## **MANDATORY SERVICE BULLETIN NO. MSB 62-045 REV. 2** **SUPERSEDES MSB 62-045 REV. 1**

Model: DA 62

Inspection of starter wiring connection.

**WORK INSTRUCTION WI-MSB 62-045 REV. 2**  
**SUPERSEDES WI-MSB 62-045 REV. 1**

Figure 1 - Correct starter wiring connection.

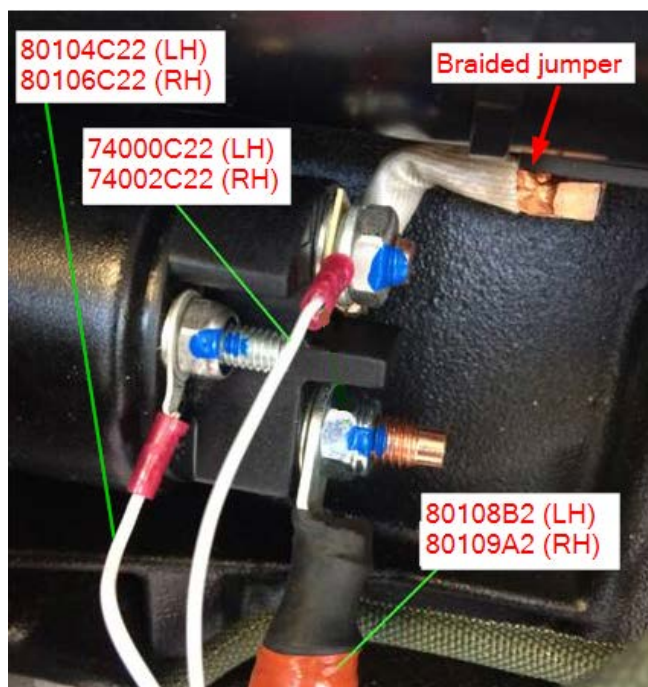
It was observed in some cases that the starter motors were wired incorrectly. The result of the mis-wire do not affect the normal operation of the starting CAS warning message reporting system. This wiring change will only correct for proper recognition of an uncommanded start condition. This Service Bulletin describes the inspection of the starter wiring and correction if required.

1. Disconnect the main battery for maintenance. Refer to AMM Section 24-31.
2. Remove the LH top cowling. Refer to AMM Section 71-10.
3. Inspect the starter wirings for correct connection. Refer to Figure 1.
  - The terminal 74000C22 or 74002C22 must be connected along with the braided jumper.

4. If the wire 74000C22 or 74002C22 is connected to the same attachment as the braided jumper as shown in Figure 1, that means that the connection is correct and you can proceed to step 8.
5. If the wire 74000C22 or 74002C22 is not connected to the same attachment as the braided jumper, the connection is incorrect and you must proceed to the next step.

6. Remove wire 74000C22 or 74002C22 from the incorrect location, and reinstall it in the correct location. Refer to Figure 1.
7. Clean the working areas and check for foreign objects.
8. Connect the main battery after maintenance. Refer to AMM Section 24-31.
9. Check all altered, replaced, repaired parts for proper function.
10. Install the LH top cowling. Refer to AMM Section 71-10.
11. Do an engine ground run-up. Refer to AMM Section 71-00.
12. Repeat the steps 1 through 11 for the other engine.
13. Make all necessary entries into the logbooks.
14. Submit the execution report to [Techpubs@diamondaircraft.com](mailto:Techpubs@diamondaircraft.com).
